## **4.0 FINDINGS AND OBSERVATIONS FROM THE RSE SITE VISIT**

### **4.1 FINDINGS**

**FIGURE 1-3. TCE DISTRIBUTION IN THE TOP OF ROCK**

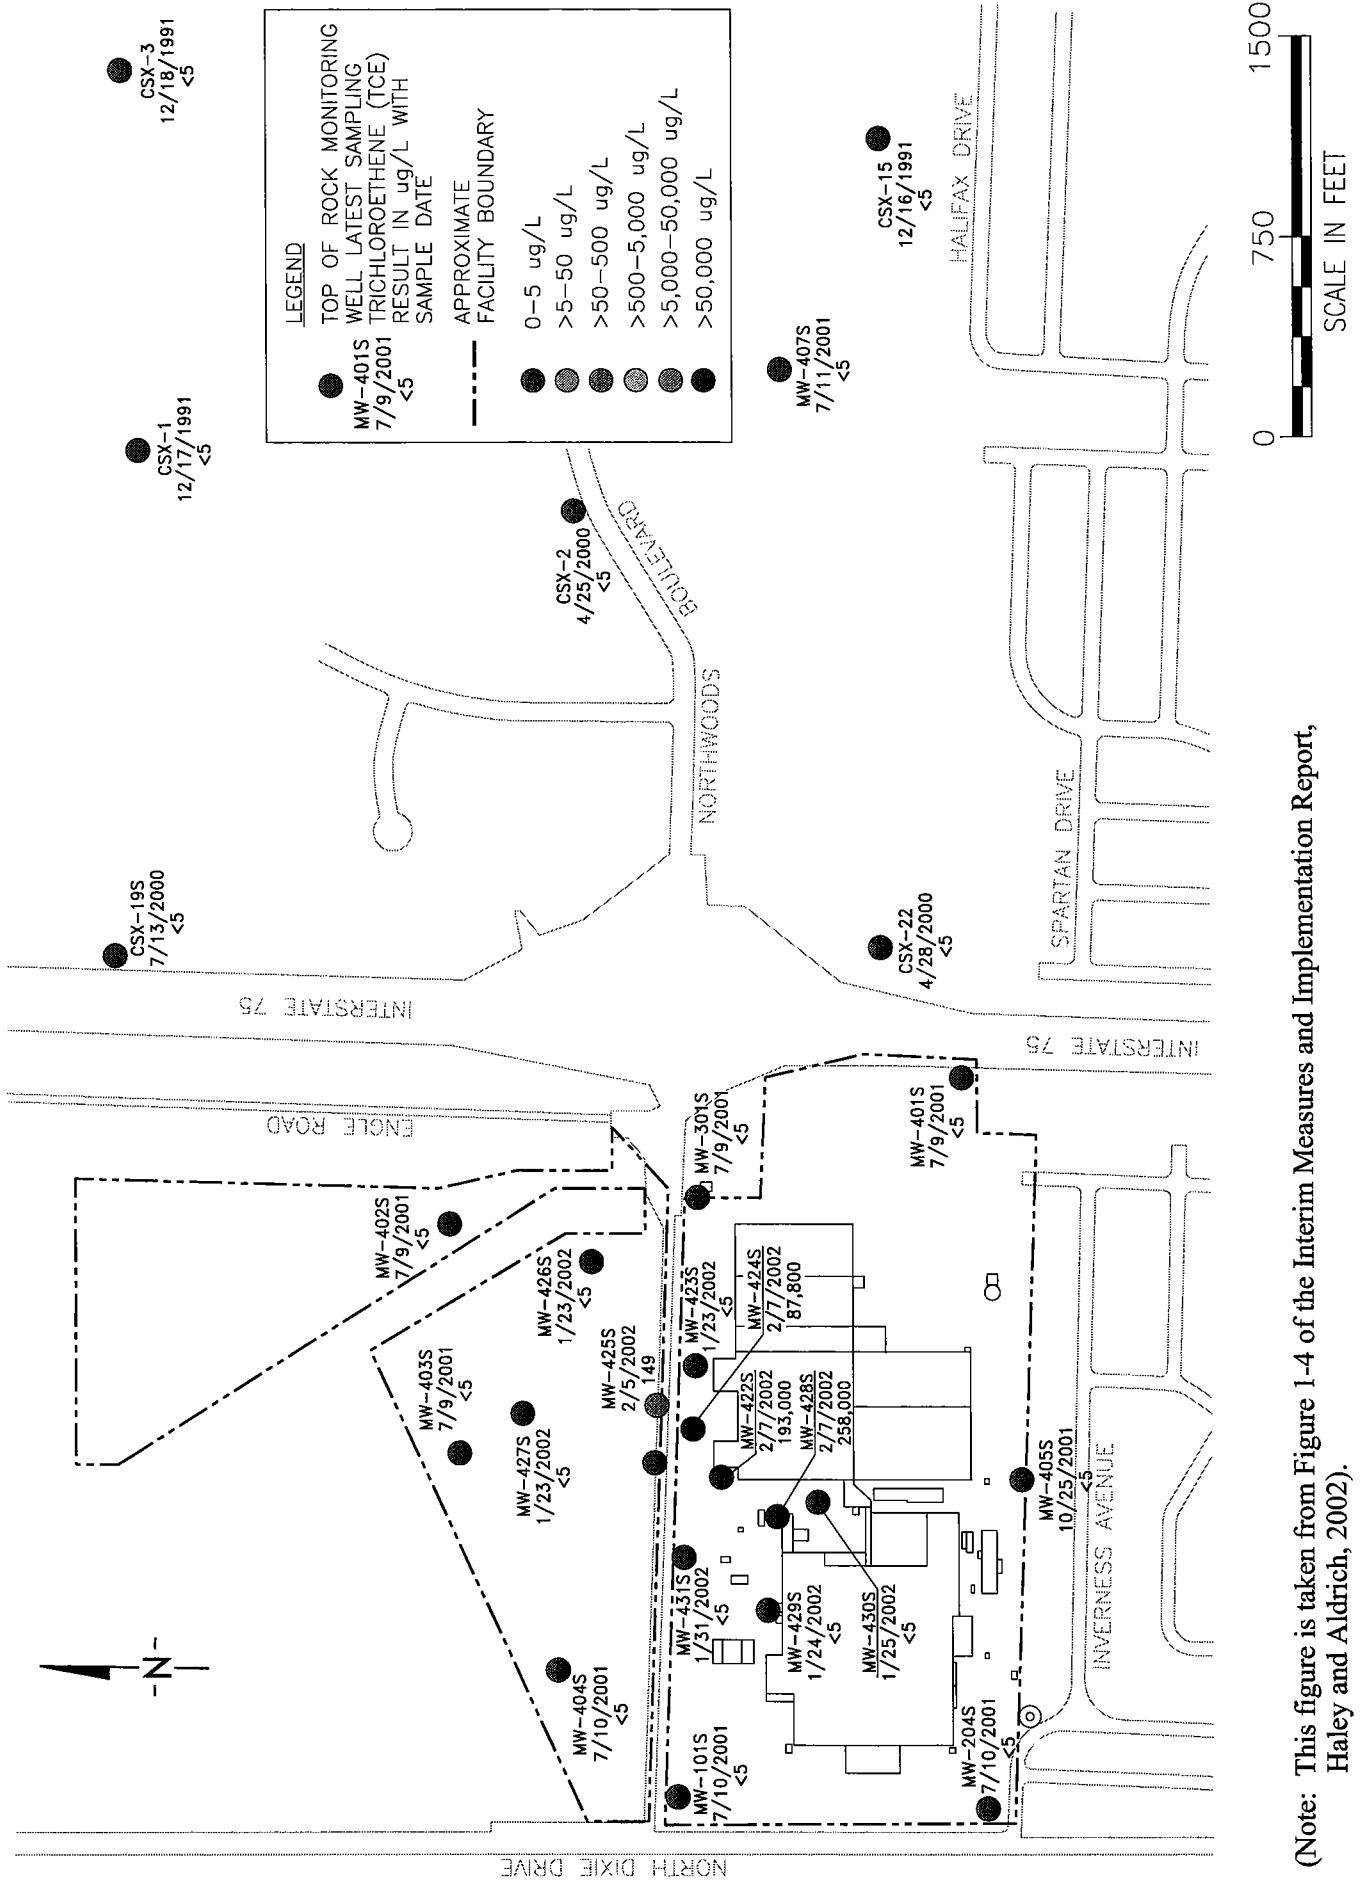
In the Top of Rock, there is no intended target capture zone and no implemented remedy because contaminated water appears to be naturally contained by the discharge of water to the underlying Sugar Rock. As shown in Figure 1-3, ground water sampling and analysis in the Top of Rock suggests that VOC contamination above MCLs is limited to four wells in the north central portion of the property (MW-422S, MW-424S, MW-425S, and MW-428S). The sampling results from other monitoring wells in the Top of Rock and interpretation of capture from the potentiometric surface map suggest that the contamination in these wells is contained horizontally. The only indications of potential TCE or cis-1,2-DCE contamination in the Top of Rock that is likely outside of the capture zone are the sampling results from 10591 Engle Road, which is approximately 500 feet to the northeast of the facility and near the Unnamed Tributary. The concentrations at this location are below MCLs and all other wells in the area (both monitoring and supply wells) have no detectable concentrations of these constituents. This well is constructed with an open interval that extends from the Top of Rock to the Sugar Rock and it is likely that TCE in this well is related to the Sugar Rock.

**Top of Rock** - The currently available ground water quality information for this unit should be used to establish a target capture zone that would likely encompass MW-422S, MW-424S, MW-425S, and MW-428S. If capture as interpreted by the potentiometric surface maps routinely and comfortably encompasses the target capture zone, then additional sampling in this formation can be limited. Select wells, perhaps one well within the plume and up to 8 wells delineating the plume can be sampled every five years to confirm migration control is still achieved. The potable drinking well at 10591 Engle Road (which has detectable VOC concentrations below MCLs) should likely be sampled quarterly, and the wells at the immediately surrounding properties (which do not have detectable VOC concentrations) should likely be sampled annually.

FIGURE 4-1. POTENTIOMETRIC SURFACE MAP FOR THE TOP OF ROCK, JULY 2002

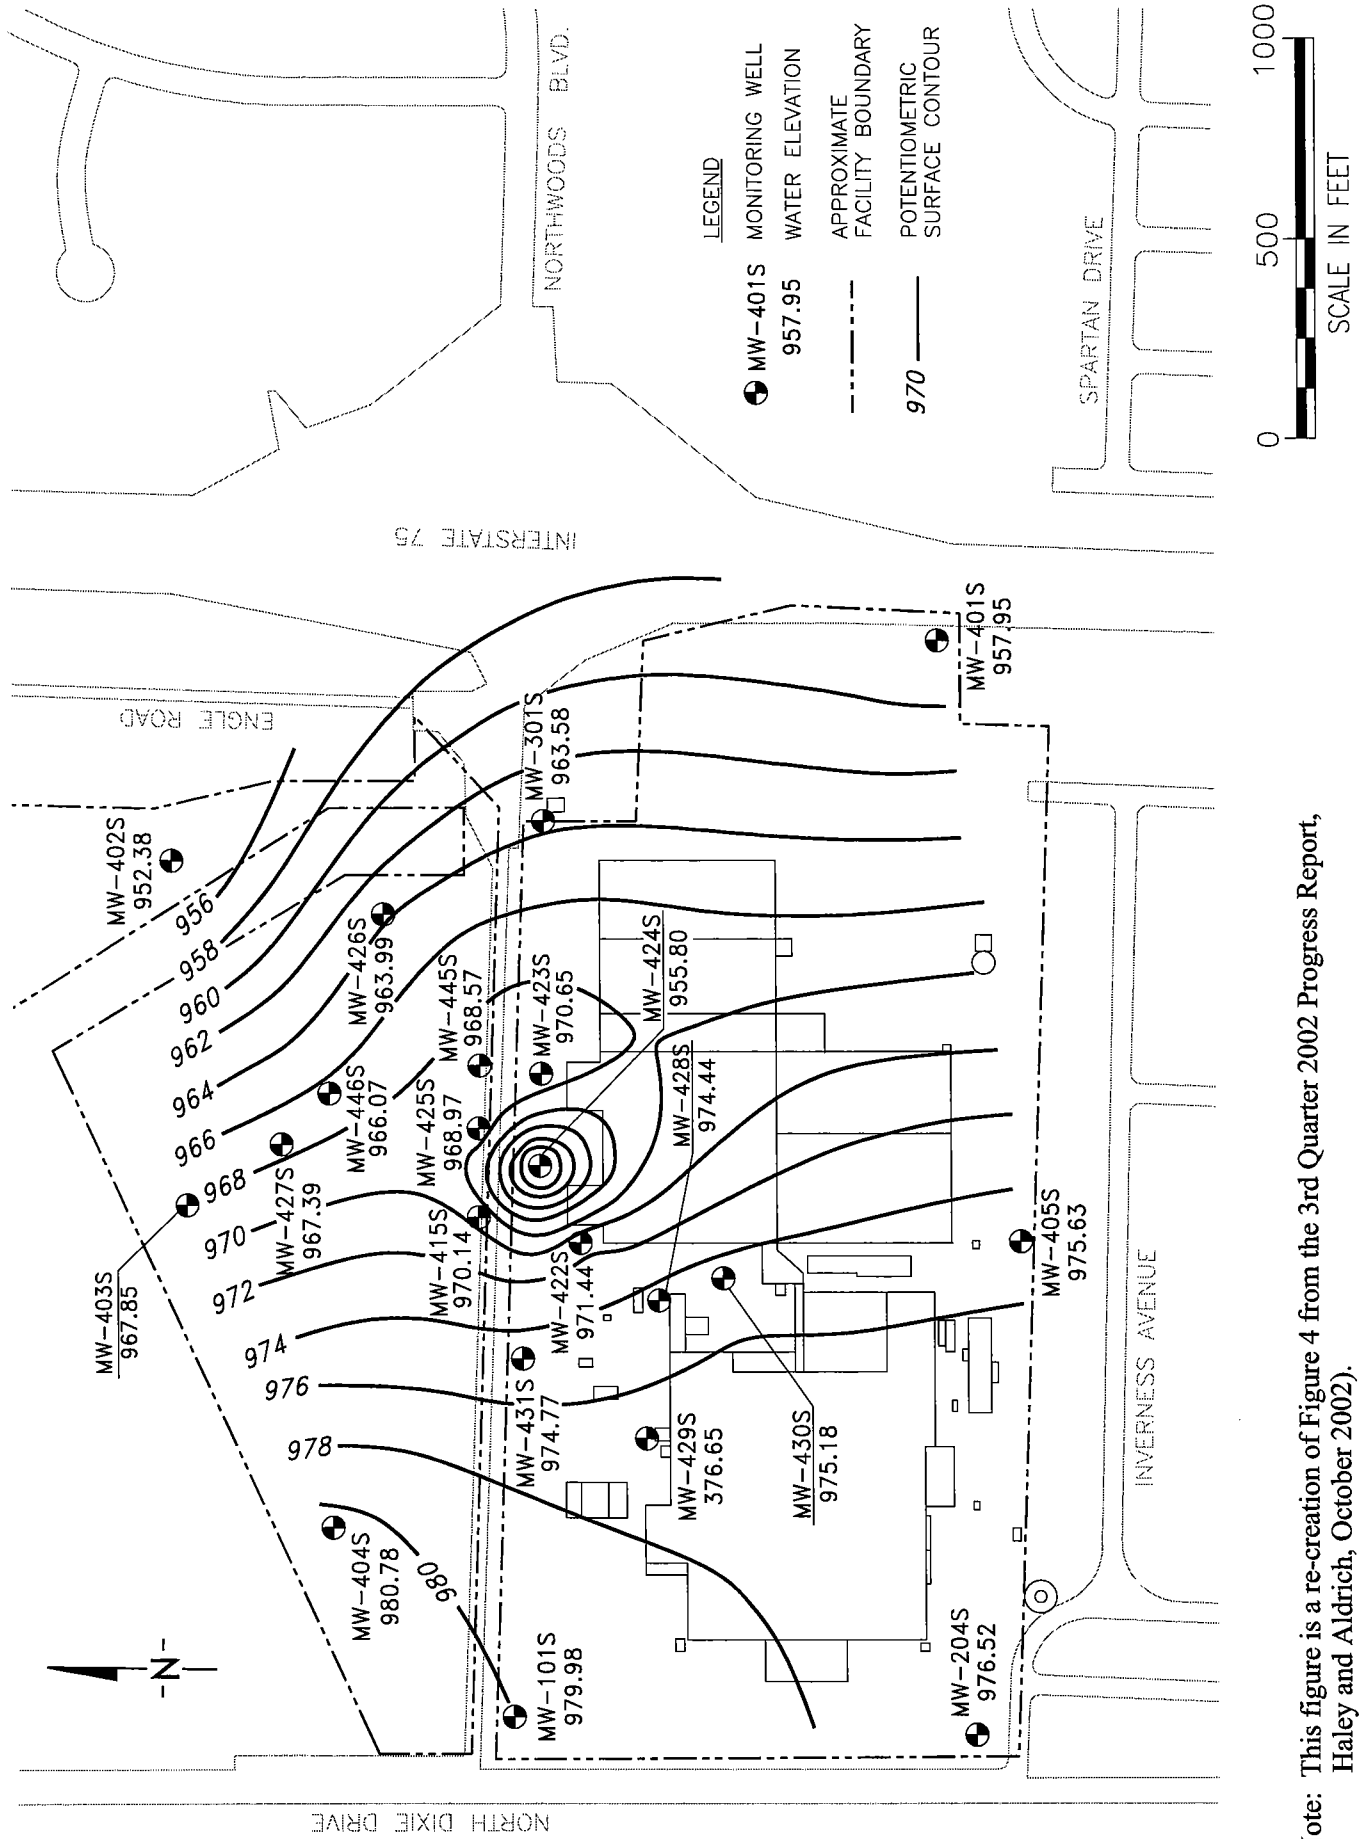
Water levels from the Top of Rock are collected quarterly and corresponding potentiometric maps are generated. Figures 4-1 depicts a typical potentiometric surface map for the Top of Rock unit. The regional water elevation ranges from approximately 980 feet above mean sea level (MSL) at the western property boundary to approximately 960 feet MSL at the eastern property boundary. A localized low in the water table is present at MW-424S where the water level is approximately 956 feet MSL. This low likely represents an area where water from the Top of Rock discharges to the Sugar Rock.

FIGURE 4-2. POTENTIOMETRIC SURFACE MAP FOR THE SUGAR ROCK, JULY 2002

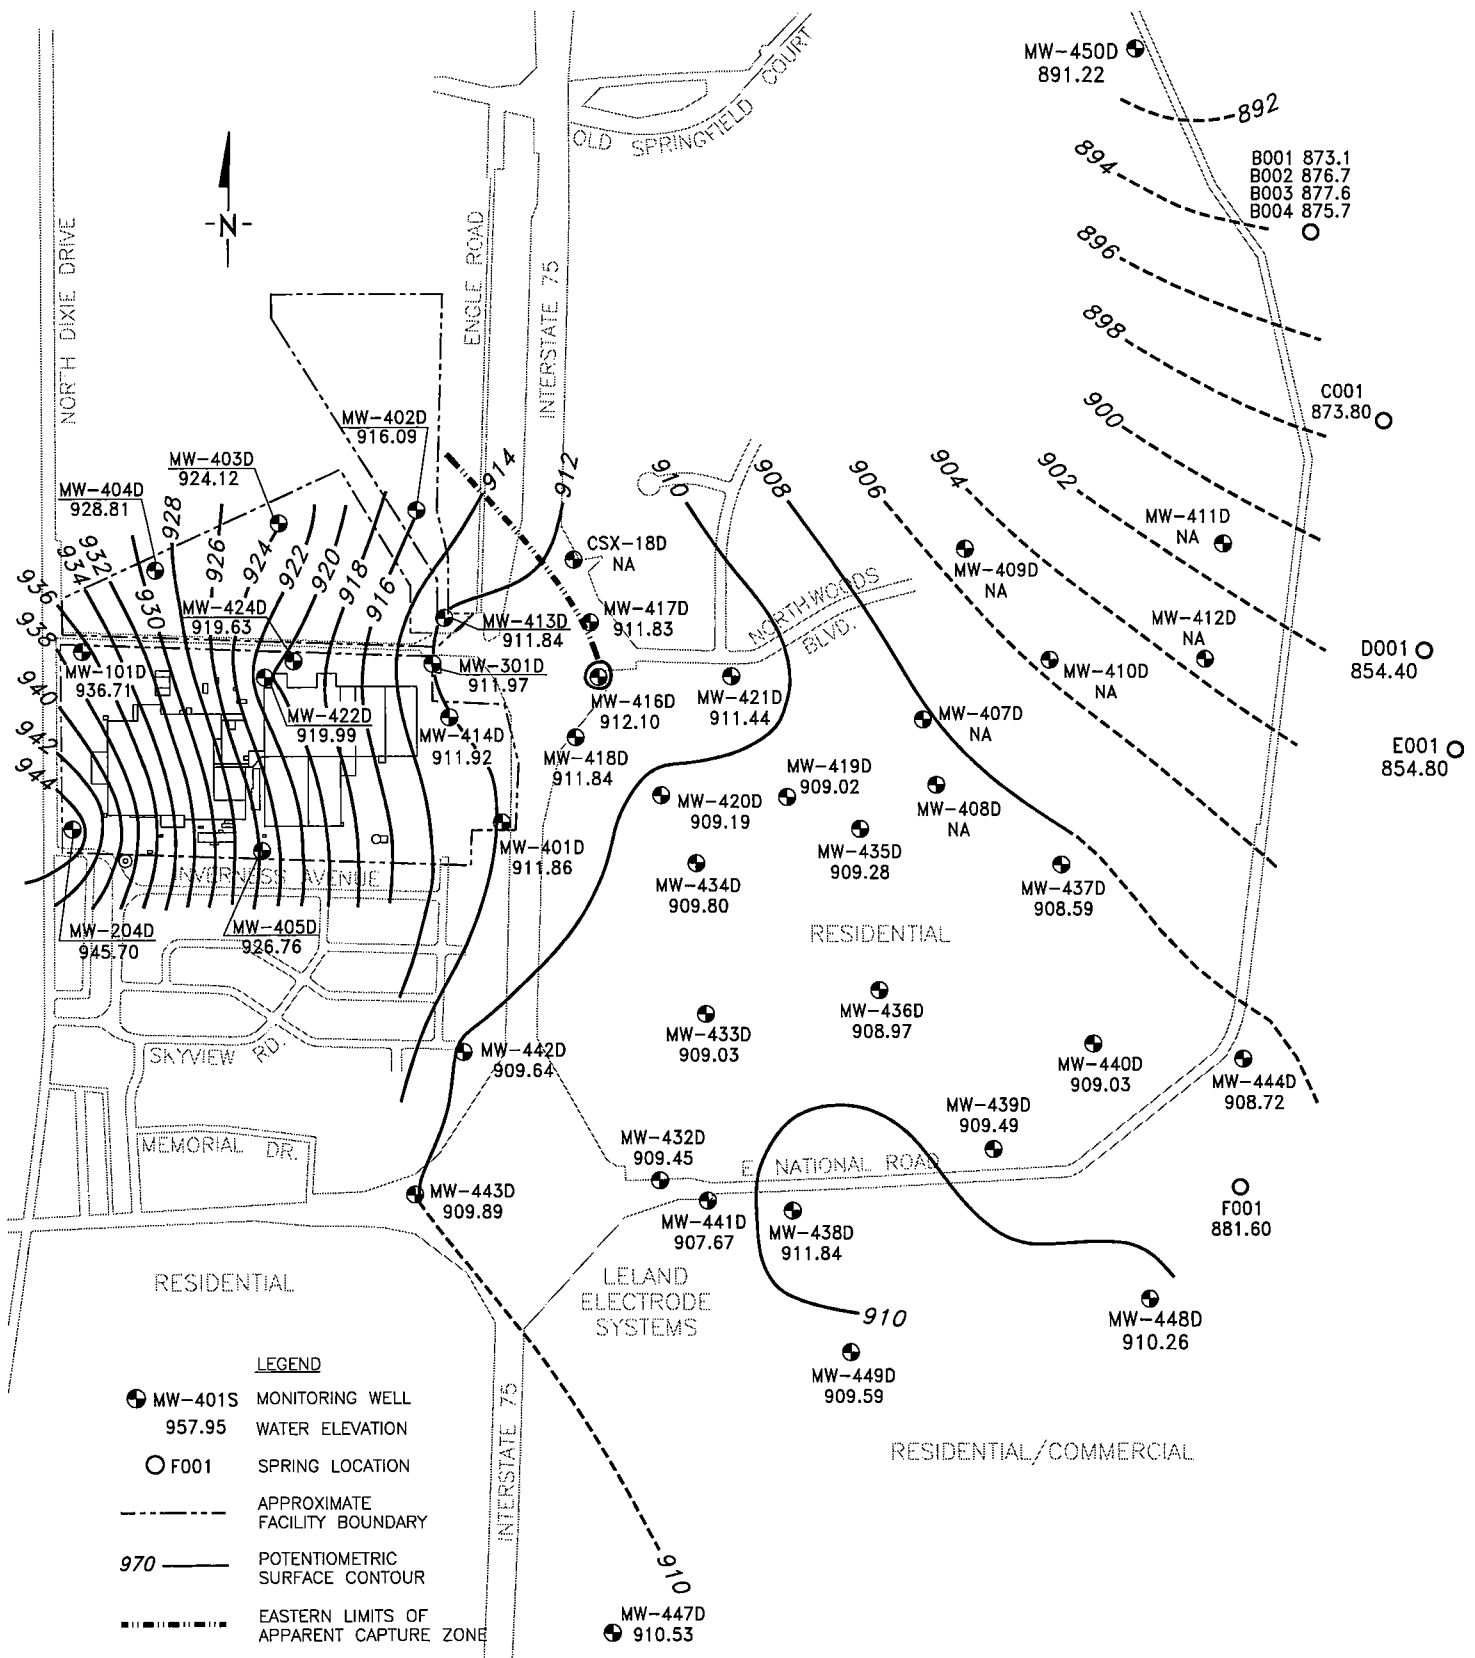
Water levels in the Sugar Rock are collected monthly and corresponding potentiometric surface maps are generated. The results are generally consistent from month to month with some variations due to local pumping. Figures 4-2 and 4-3 depict typical potentiometric surface maps for the Sugar Rock. The primary difference between the two maps is presumably the affect of variable pumping at the Leland/Smith facility. The water elevation across the property typically ranges from 945 feet MSL at the western boundary to approximately 915 feet MSL at the eastern boundary. No mounding is obvious near MW-424D to correspond with the cone of depression near MW-424S in the Top of Rock. Influence from pumping at P-301 at the northeastern corner of the property is evident in both figures. Although the capture zone boundary is not completely outlined, there is sufficient resolution to draw streamlines and outline the estimated horizontal capture zone. The hydraulic gradient to the east of the pumping is relatively flat for approximately 2,000 to 3,000 feet but then steepens again as it turns to the north east. The relatively flat gradient is perhaps in part due to the reduced amount of water flowing through that portion of the aquifer due to pumping from P-301 and from the Leland/Smith well to the south, which pumps an estimated 80 gpm on average. There is a relatively small component of flow from the facility to the southeast in July 2002, but it appears that a more pronounced component is present in February 2003 (Figure 4-3) in which an inward gradient for the Leland/Smith well is apparent.

In the Sugar Rock, the target capture zone is the eastern property boundary. The potentiometric surface maps suggest that capture is provided for ground water leaving the northern portion of the eastern property boundary but that capture is not likely provided along the southern portion of the eastern property boundary. Sugar Rock monitoring wells (MW-401D and MW-405D) in the southern portion of the property, however, routinely have either no detectable VOC concentrations or concentrations only slightly above detection limits. The concentration trends in downgradient wells MW-413D, MW-416D, MW-418D, and MW-420D are analyzed in the progress reports to evaluate capture. Based on the trends and the potentiometric surface maps, the RSE team believes that MW-413D, MW-416D, and MW-418D are generally within the capture zone and that MW-420D is likely beyond the capture zone. One possible interpretation of the concentration trends is that concentrations in MW-413D and MW-416D are remaining relatively unchanged as impacted water travels past these points to the extraction well, and the concentrations in MW-418D have decreased as pumping has entrained cleaner water from the southern portion of the property. If this interpretation is correct, the MW-418D concentrations may stabilize either above or below the MCLs over time. Concentrations at MW-420D would be expected to continue declining until background concentrations are reached.
